SERVICE BULLETIN

AIRCRAFT EFFECTED: Bushbaby

BULLETIN NUMBER: SB006

SUBJECT: Old fibreglass flaperon chord length

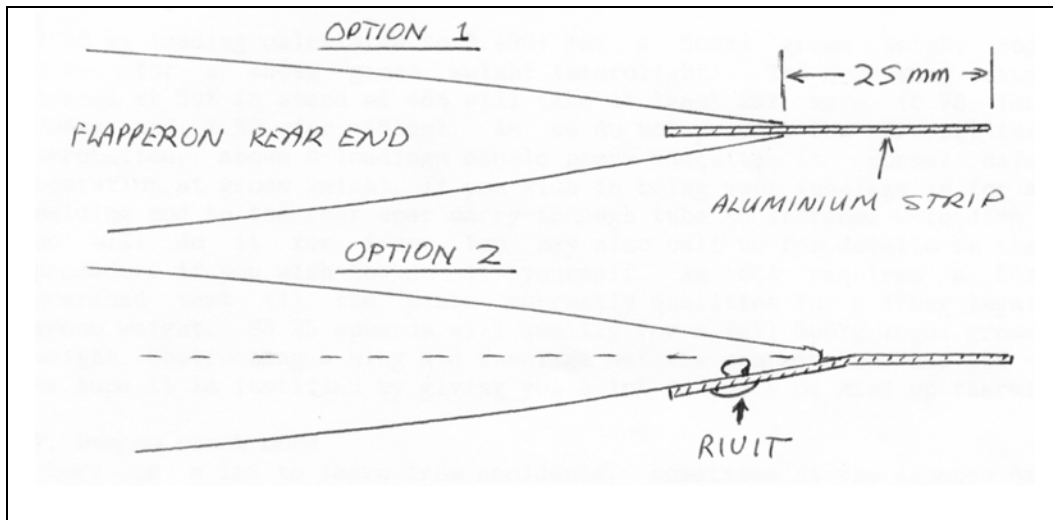
PROBLEM: All fibreglass flaperons supplied in early kits up to SN019 have the pivot point at 28% of the chord.

This causes the ailerons to snatch and could contribute to flutter.

A better position for the pivot point is 25% of the chord.

There is an easy rectification for the condition by simply extending the chord line of the entire flapperon length by 25mm.
A strip of aluminium can be bonded or riveted to the trailing edge.
